SECTION 00 91 12 – ADDENDUM NO.2

- A. Project Name: Proposed Improvements for C1 and C2 Hangars, 1200 Capital Airport Drive, Springfield, Illinois 62707
- B. Owner: Springfield Airport Authority
- C. Architect: j.h. petty and associates, ltd. architects
- D. Architect Project Number: 2024-077
- E. Date of Addendum: May 29, 2025

P1.1

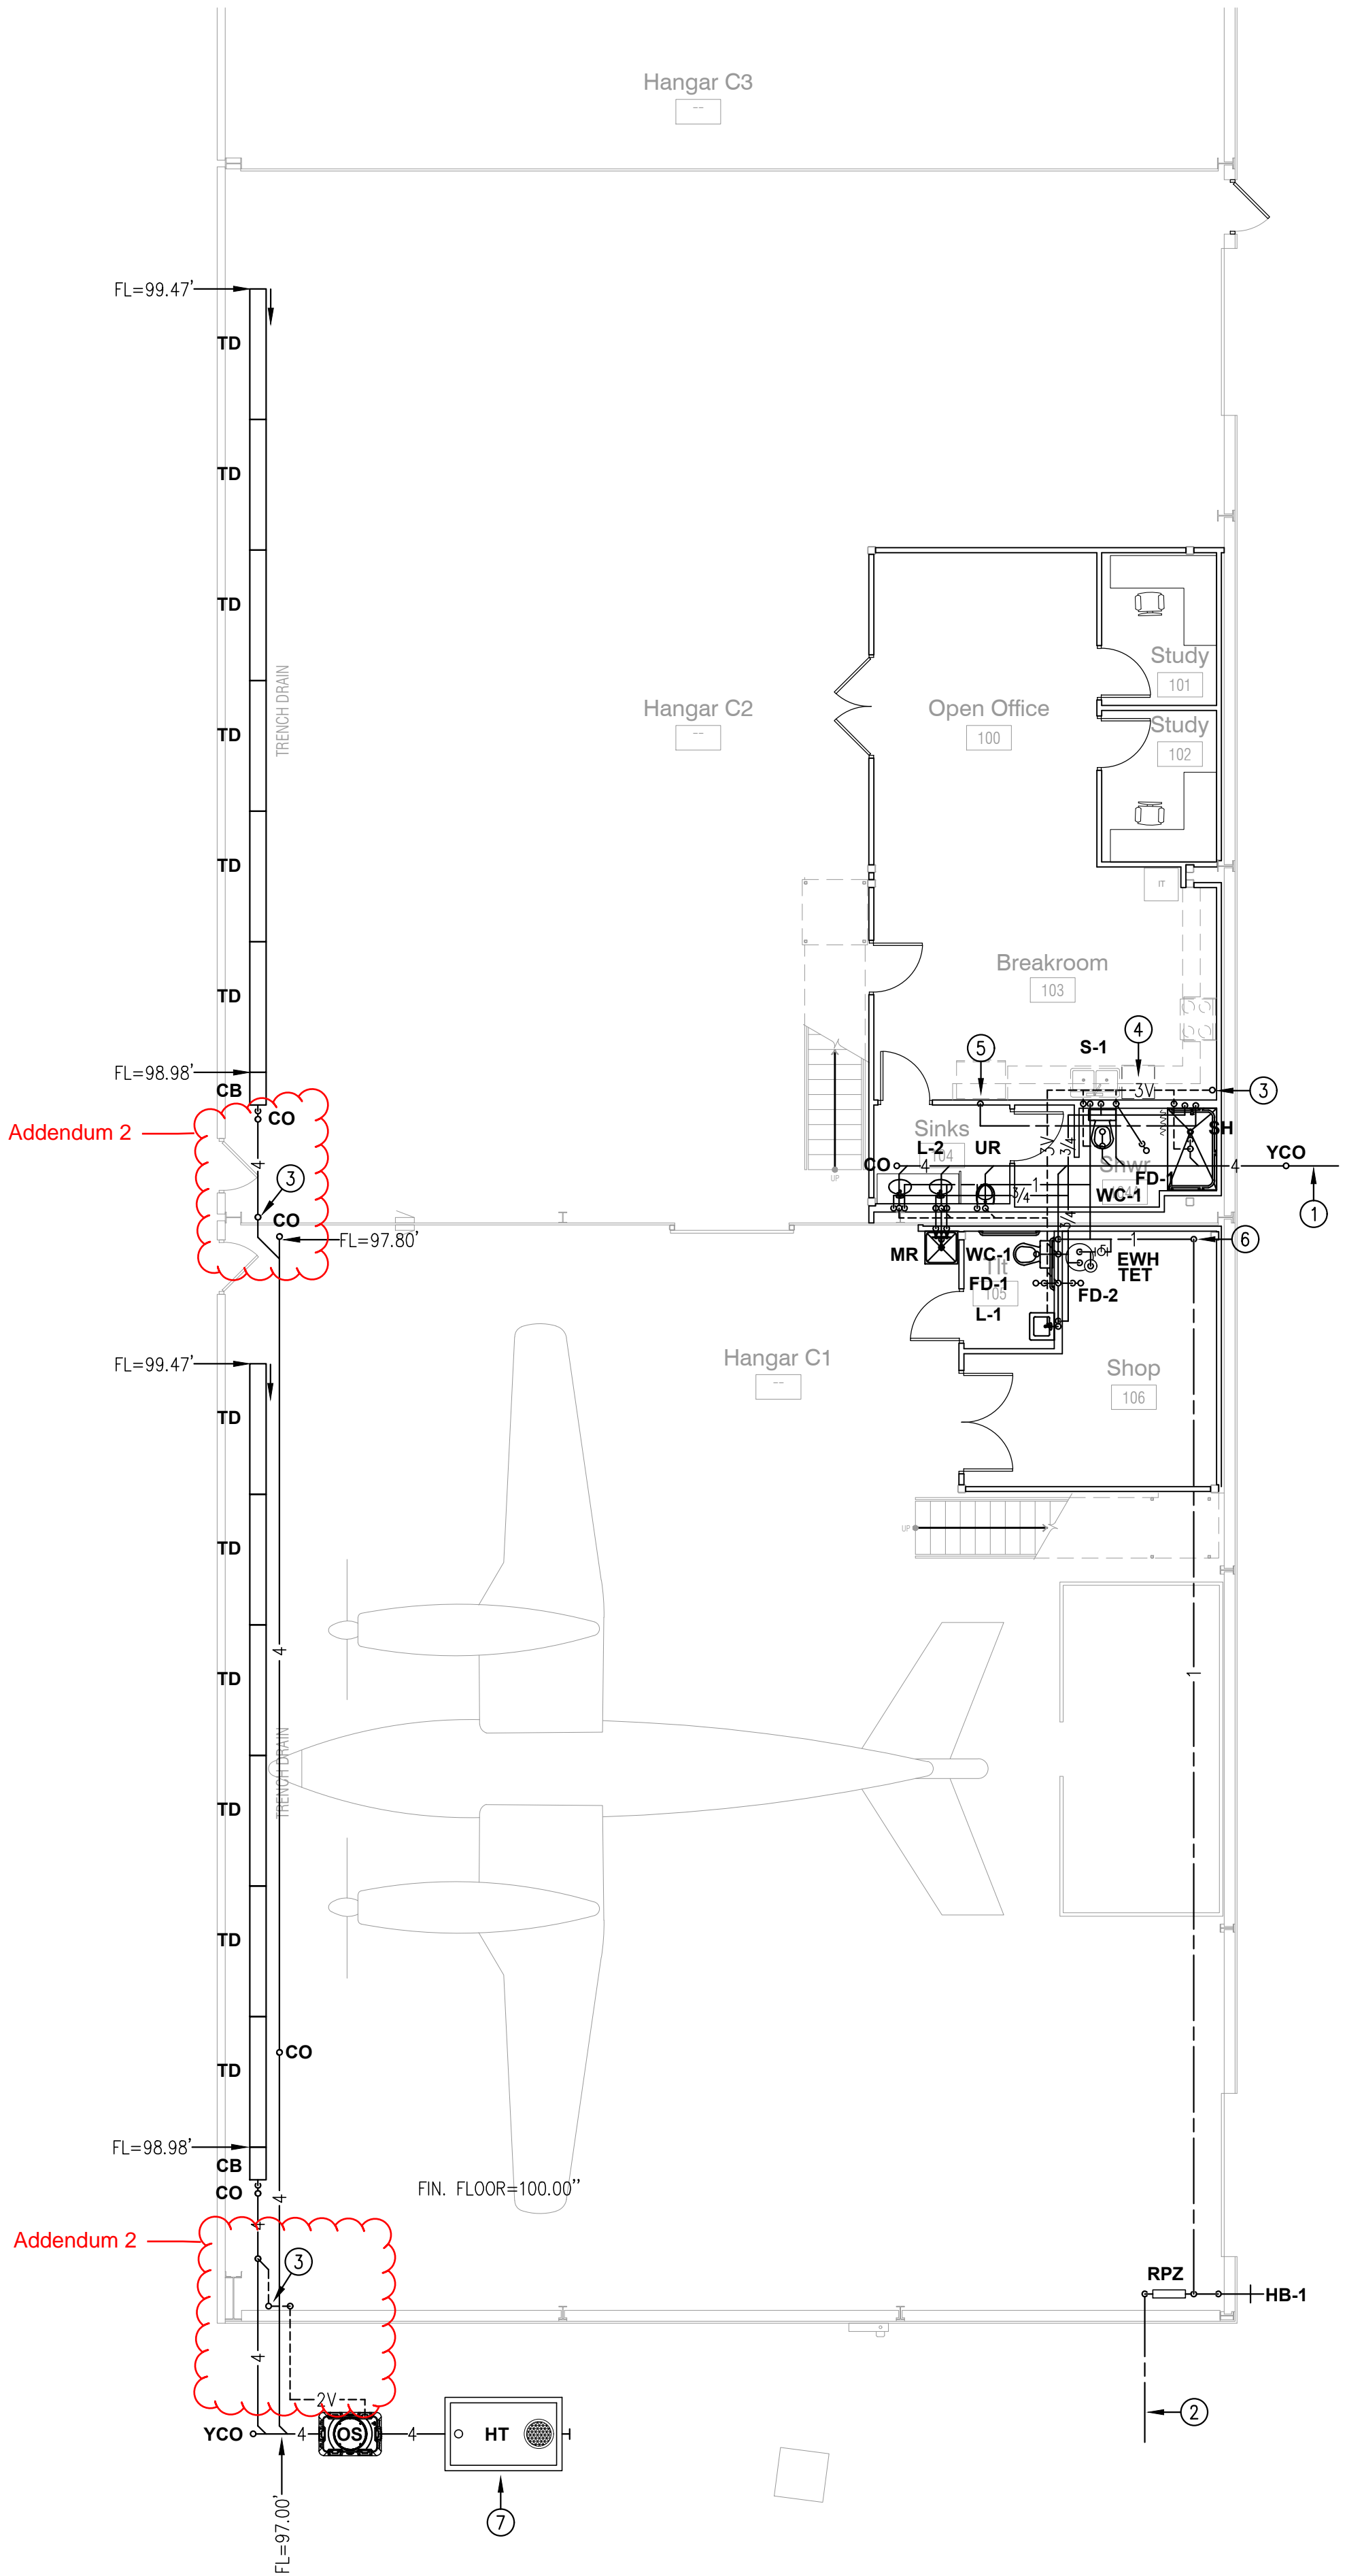
1. Detail 19 PARTITION TYPES: All partition types to be revised to show FRP panels being installed up to 48" above finished floor level on the hangar side only.
- B. Sheet P1.1
 1. Vents for trench drains relocated/reconfigured for both hangar spaces C1 and C2 to avoid interference with hangar doors and allow potential for trench sharing with drain line to minimize floor cuts.
- C. Sheet P3.1
 1. Plumbing Schedule: Trench Drain (TD) and Catch Basin (CB); A CB is installed at the downstream end of each TD. Revisions to model/order numbers to reflect additional accessories for complete install for the two fixtures to connect together.
